DESIGN REVIEW COMMITTEE
WELCHES 40-UNIT MULTI-FAMILY DEVELOPMENT

Z0323-18-D

October 9, 2018

LANDSCAPE PLAN

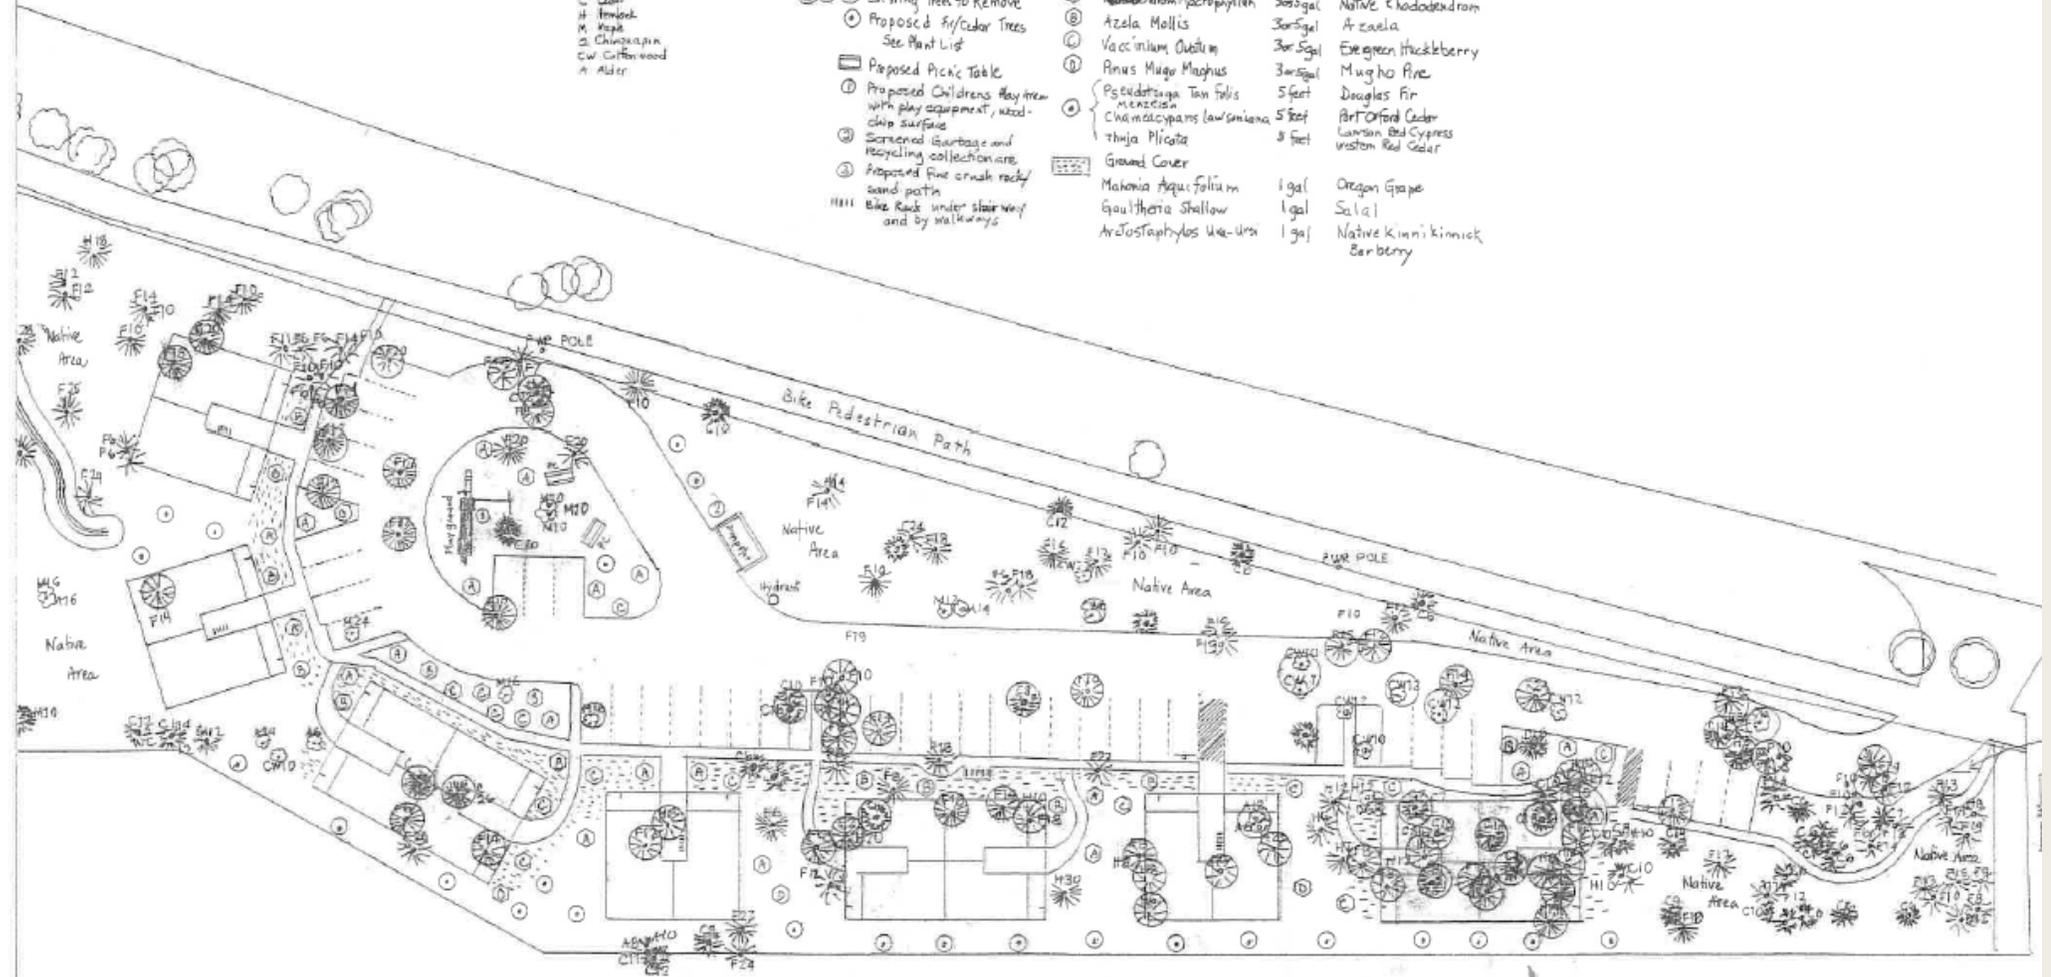
- Section 1009 – Landscape
 - Staff identified several issues related to the landscape design including a requirement for additional buffering between the development and adjacent single family homes, a guarantee of the landscape materials, use of evergreen trees that meet the dimensional standards of the ordinance, evidence that the size/spacing and ground cover requirements will be met, and additional information related to irrigation of landscape.
 - These issues are addressed by conditions of approval.

BUILDING MATERIALS

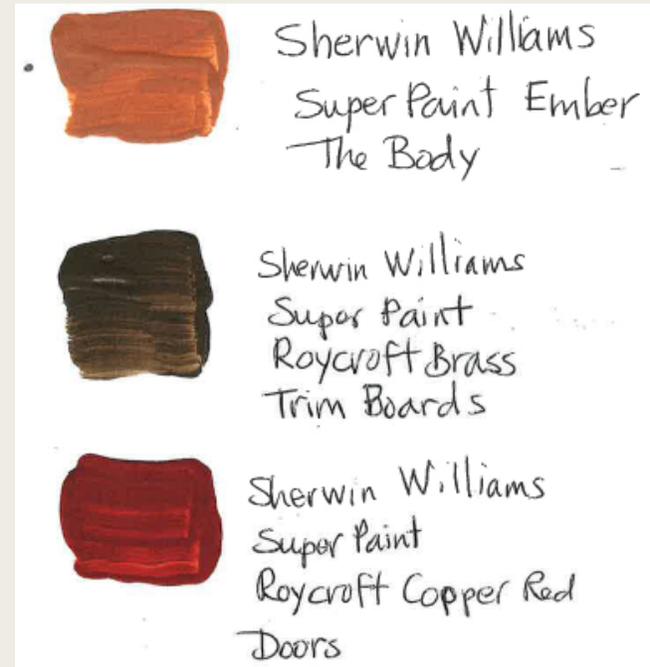
- The primary façade material proposed for buildings in the development is “T1-11” siding which is a common residential building material in the region. This is the same material as another of the applicants developments, pictured below. Buildings are proposed to be painted in warm, rustic tones. Roofs are to be clad in brown architectural roofing shingles.
